☐ Reviewed (No Comment)	
☒ Reviewed (See Comment)	
☐ Reviewed (Resubmit)	
Checked only for conformance with the design-concept of the project and with the information given in the contract documents; review of shop drawings shall not release the contractor from responsibility for deviations from drawings and specifications. Shop drawings, including schedules, quantities, dimensions, fabrication, installation and coordination requirements, shall be checked and verified by the Contractor.	
DATE AND WHITTIER, INC. Architects, Project Managers	Date <u>10-7-96</u>

YOUR Northeastern Log Home BLUEPRINTS

DRN. SW	CODES	DESIGNED TO MEET THE B.O.C.A. NATIONAL BUILDING CODE
DATE	PLAN NO.	NECCO INC. / ALBURN WELCOME CENTER
8-9-94	NE-15923	SHT. NO. 1
SCALE 1/4" = 1'-0"

NECCO INC. /
ALBURG WELCOME CENTER

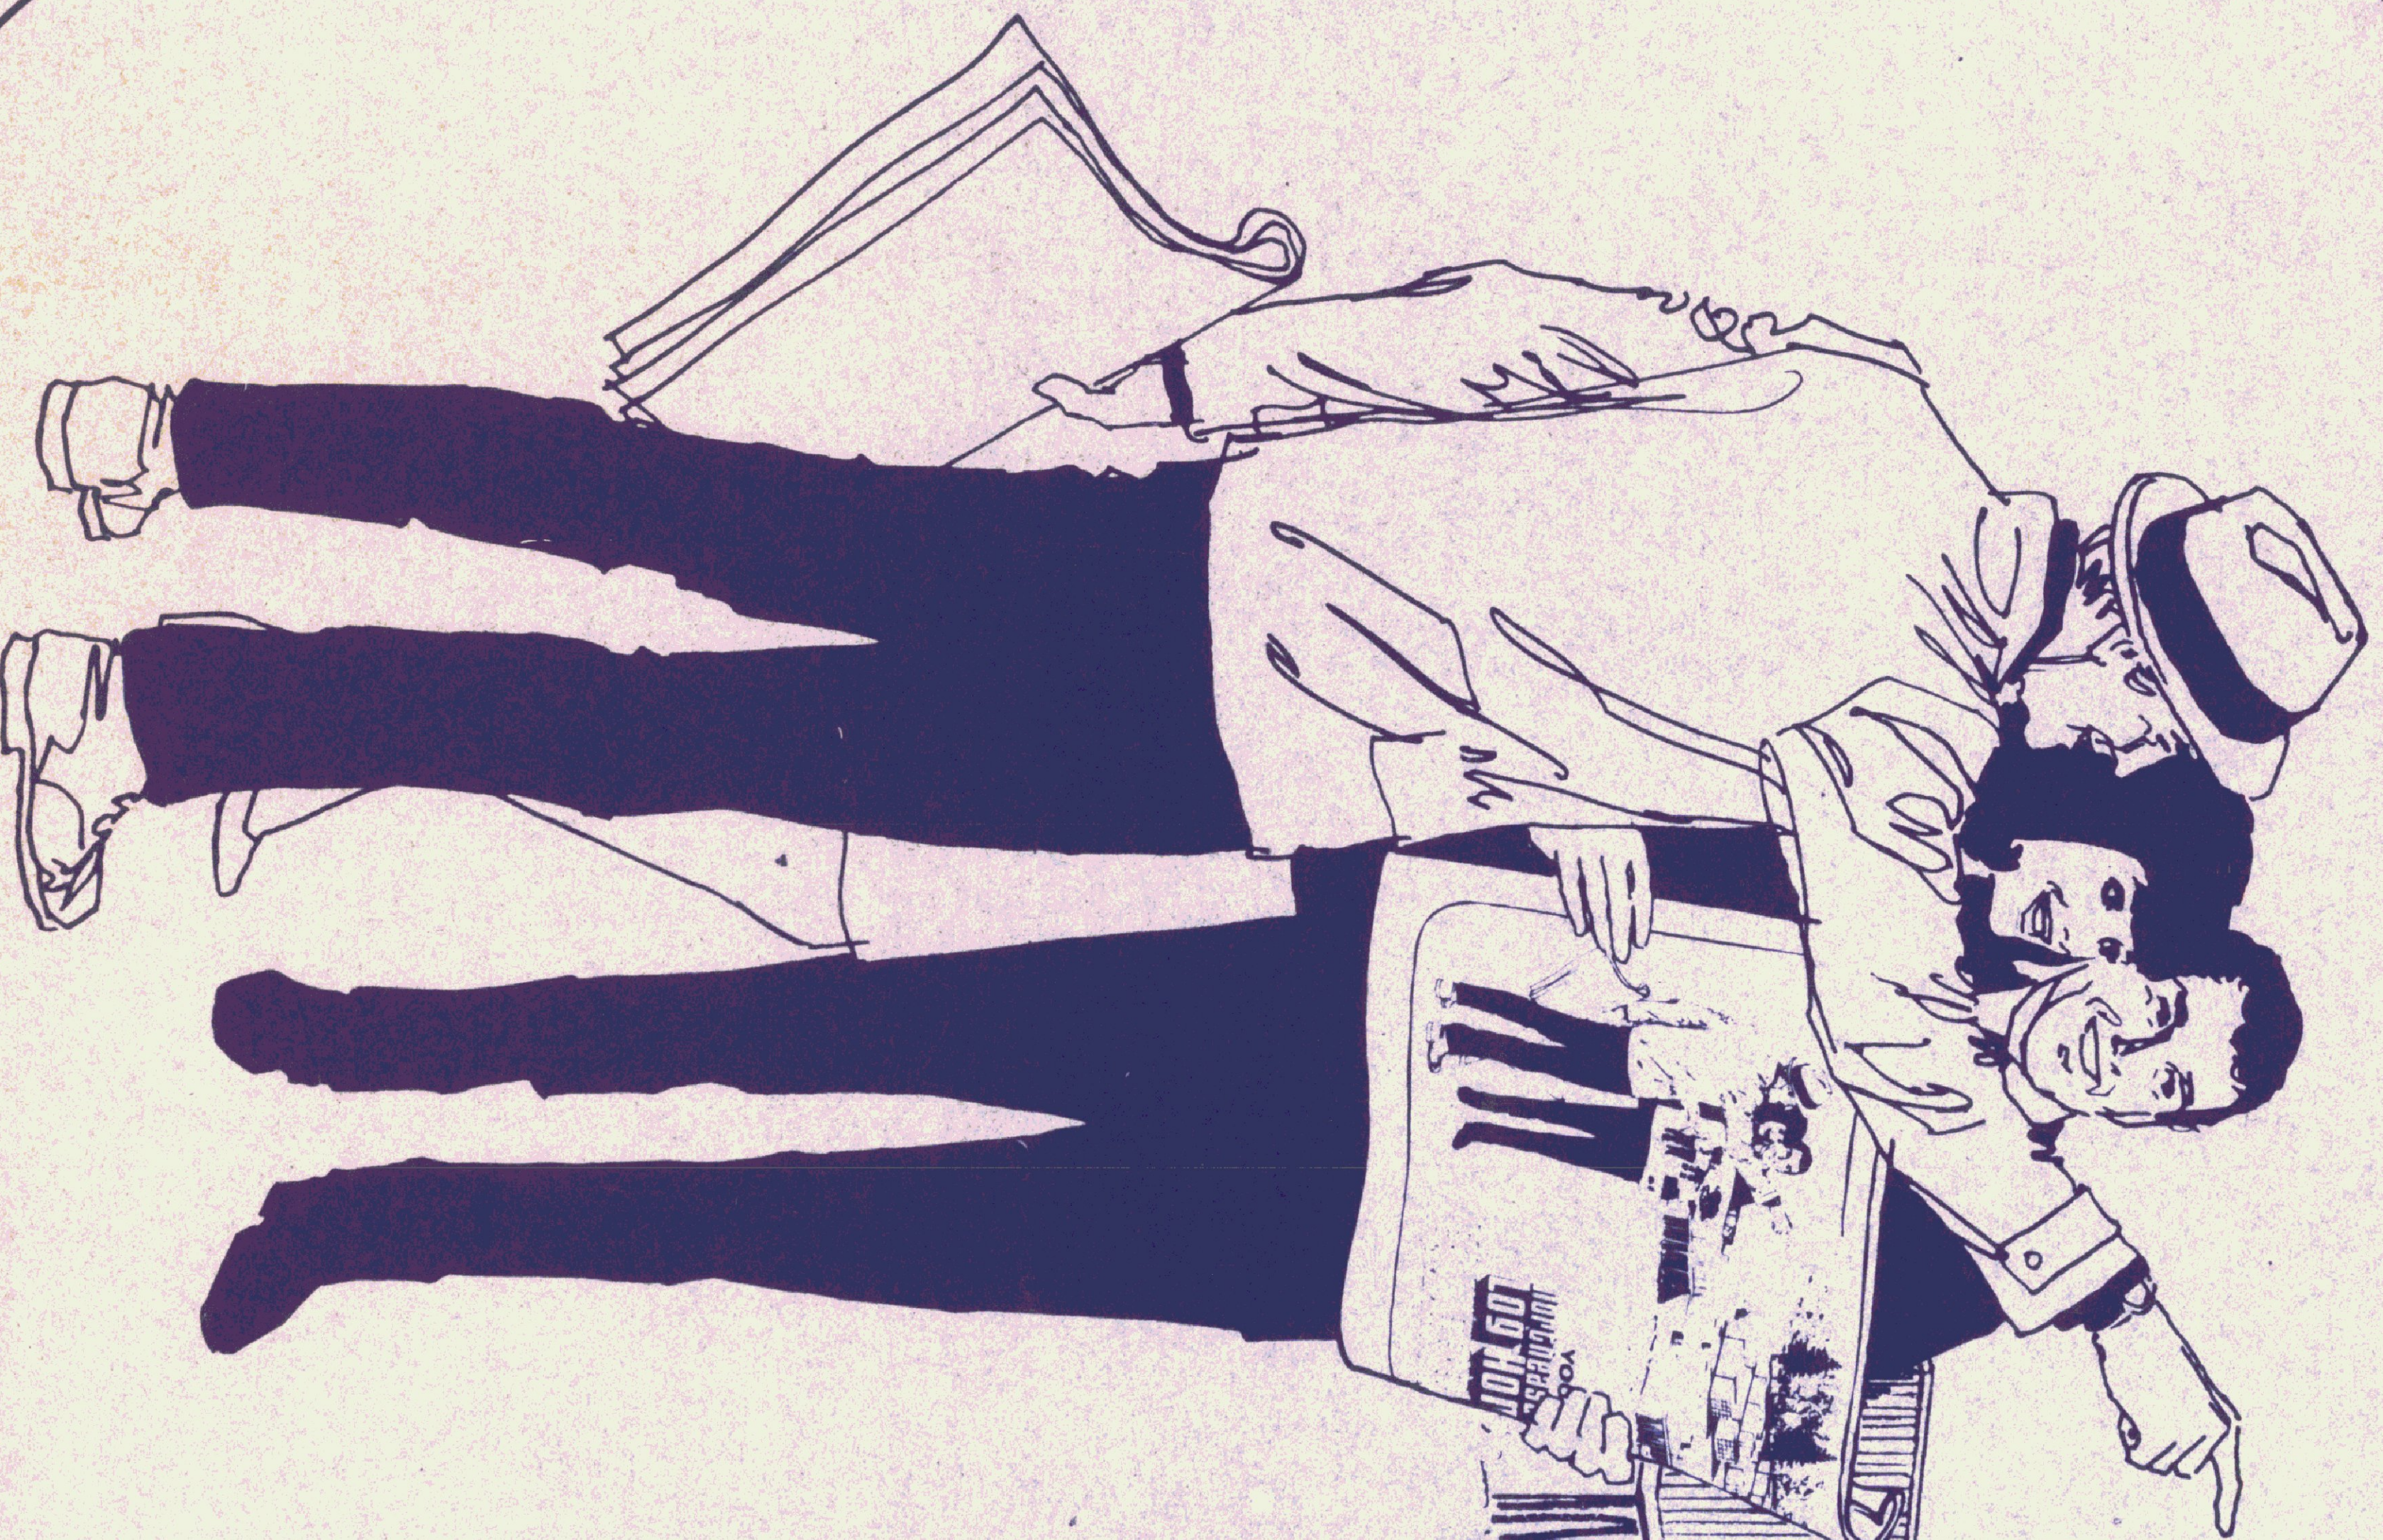
1. See work-ups
2. Note re: layout work by others
